**Notice of Planning and Zoning Commission  
AGENDA**

Consideration and possible action on a recommendation to City Council for a variance request for gravel in lieu of asphalt or concrete for the parking lot of the Montgomery Grove located at 22016 Eva Street.

Re: Variance Request  
The Montgomery Grove  
City of Montgomery

S:\ENGINEERING PROJECTS\10856 - MONTGOMERY GROVE SITE PLAN\03 CAD\DESIGN SET\BASE-SITE PLAN-10856.DWG Sep. 23, 2022-9:59 AM GARI LYNN

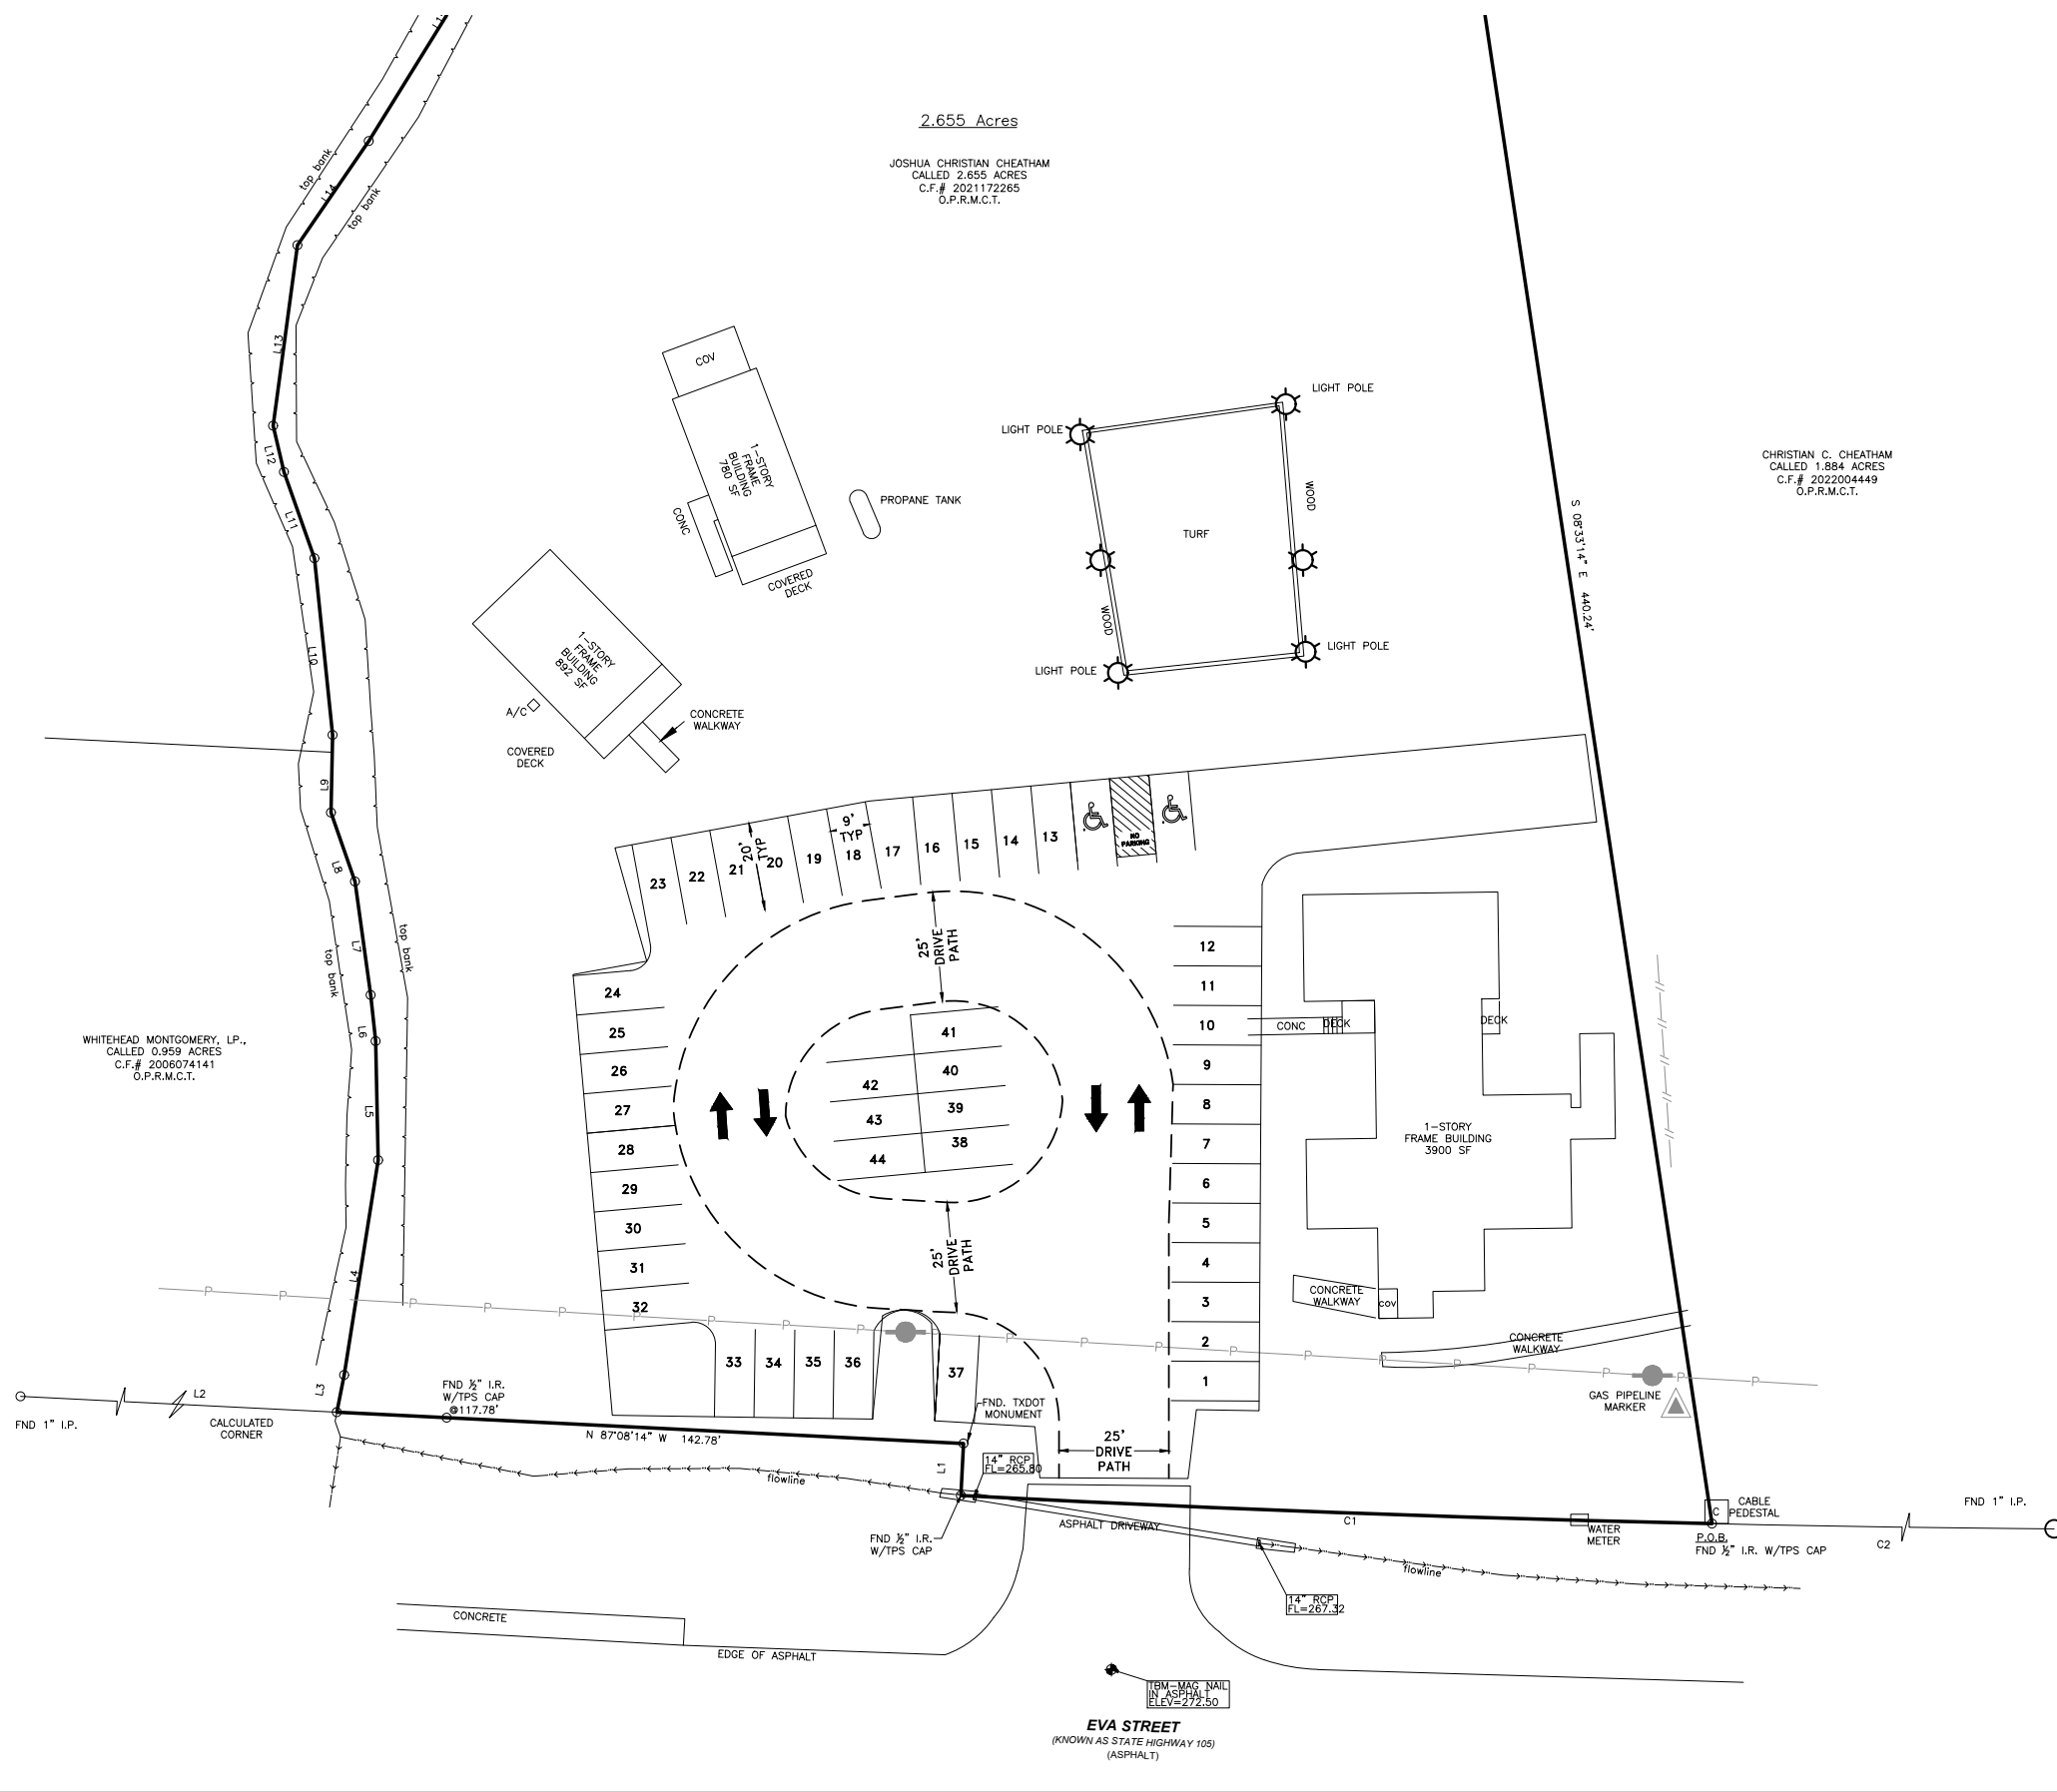
We recommend the request be tabled until additional information is received including an escrow agreement is entered into and engineering plans provided showing the full scope of the new improvements and their impact that follow the current City Ordinances. Based on planned improvements stated by the developer (enclosed), the developer plans to install additional lighting which will require a lighting plan and construction of a stage and other structures in an area that is likely within the floodplain. Additionally, the information recently provided by the developer showing the proposed parking layout is contradictory regarding the location and number of ADA spaced.

## PRELIMINARY SITE PLAN

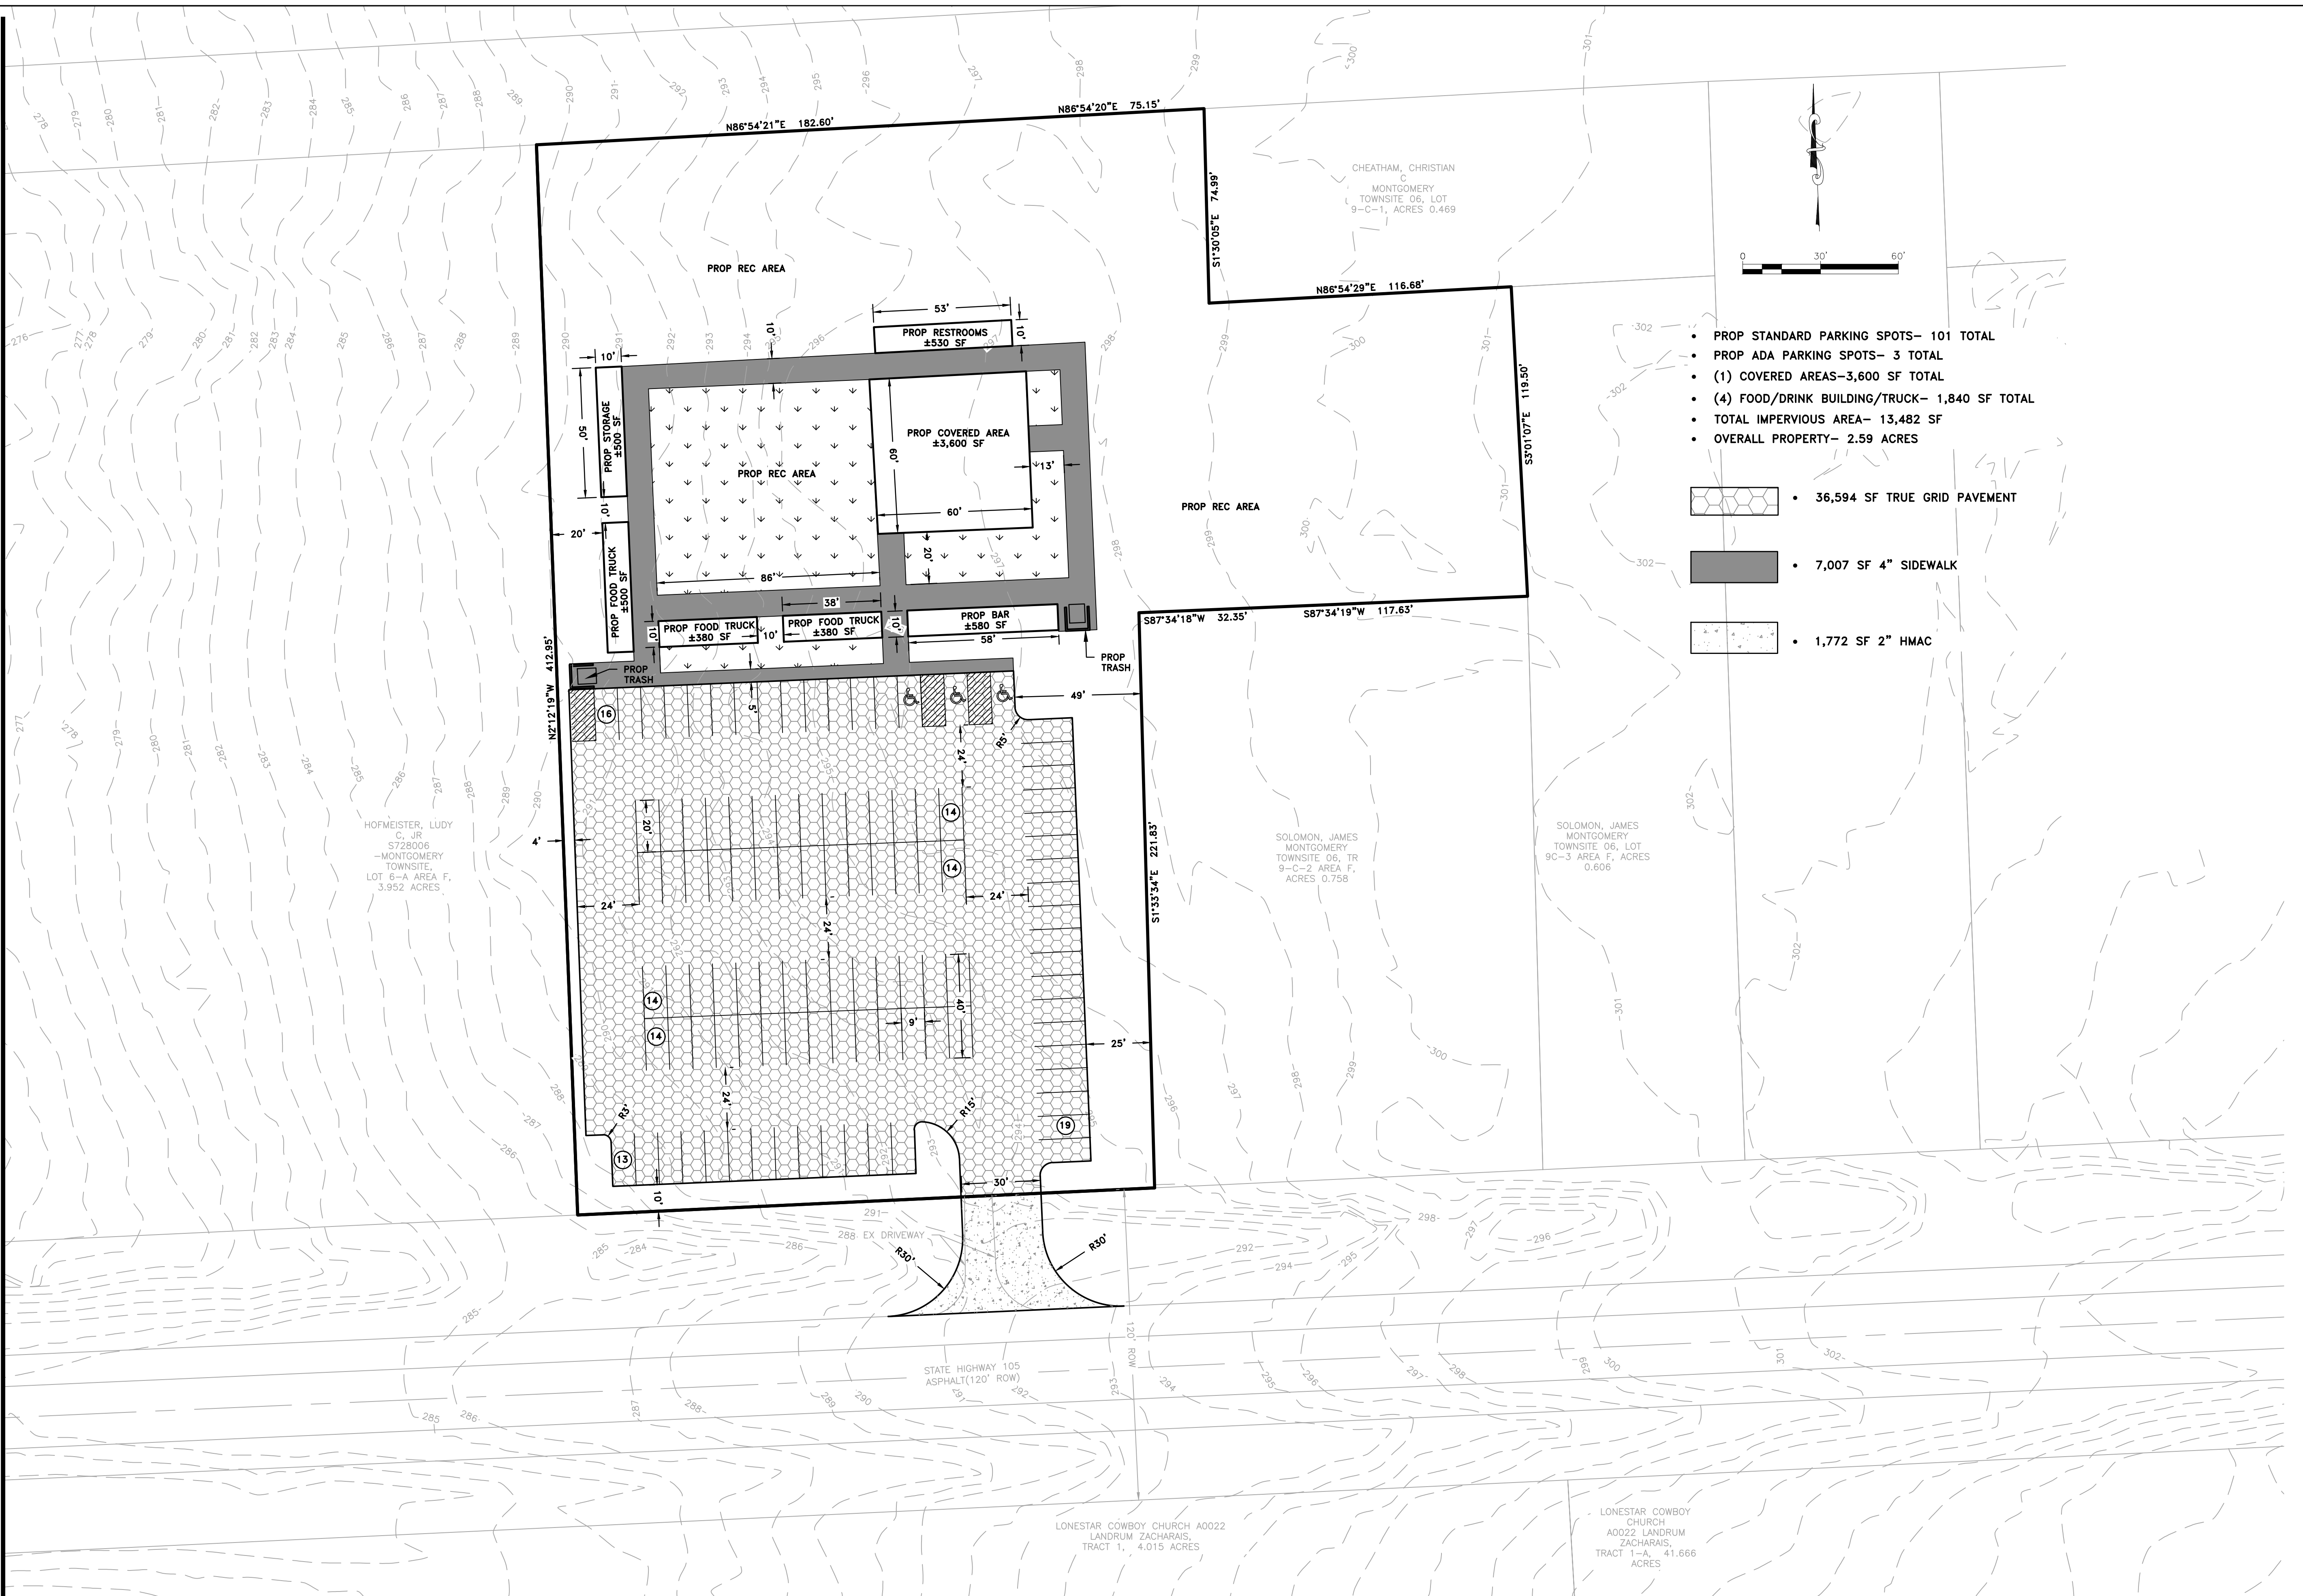
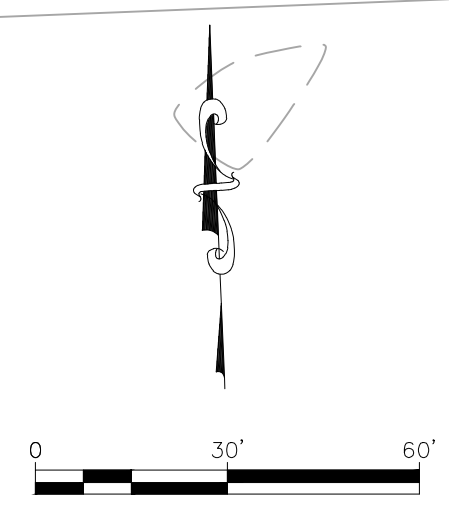
We offer no objection to the concept of using permeable paving system on the parking areas and secondary drive aisles. However, we would recommend the main drive aisle off the driveway be constructed of asphalt or concrete for a total length of approximately 75’ from the edge of pavement of SH-105 to allow for adequate deceleration space. The Developer will need to submit final details and specifications including a drainage analysis confirming detention is not required with his construction plans for review and approval by the City.
